Change Notification #: 111413 - 00

**Change Title: Intel® Desktop Board D2700MUD,
Boxed and Bulk
PCN 111413-00, Product Material,
Supplier change for Clock
Generator and SM PWM IC and
BIOS Update**

Date of Publication: April 2, 2012

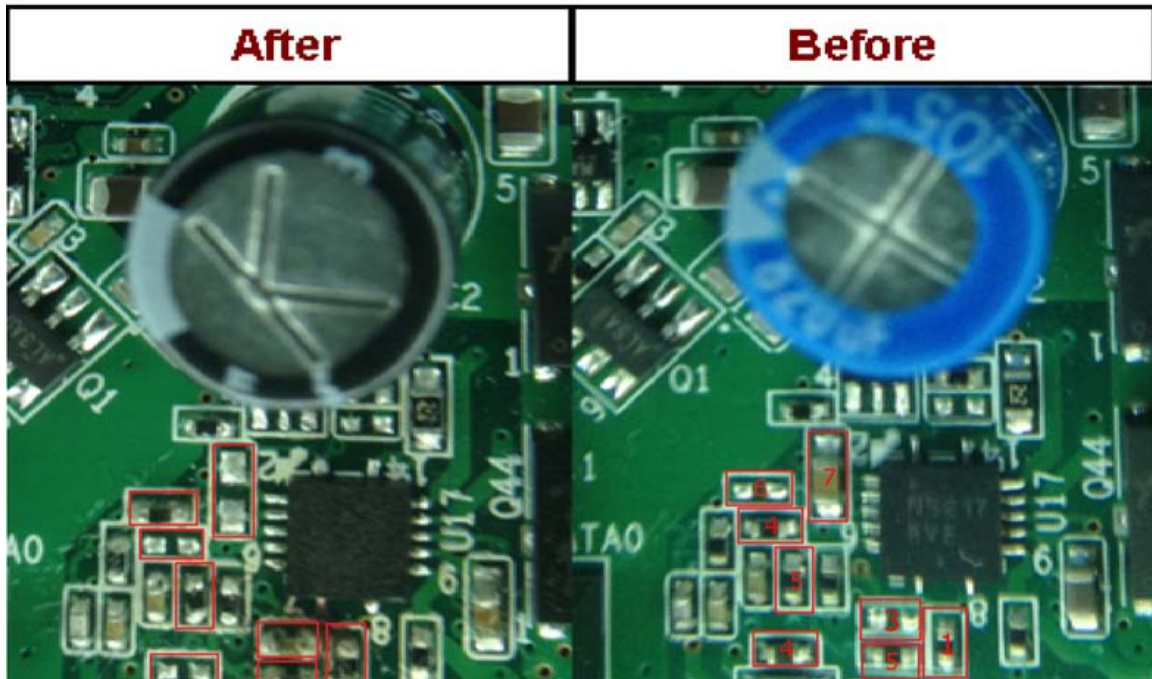
1. BIOS update from MUCDT10N.86A.0067 to MUCDT10N.86A.0069. To access the release notes or get a copy of the BIOS for evaluation, go to <http://downloadcenter.intel.com>.
2. Replace the clock chip with a Silego part in order to improve supply availability.

Before

After
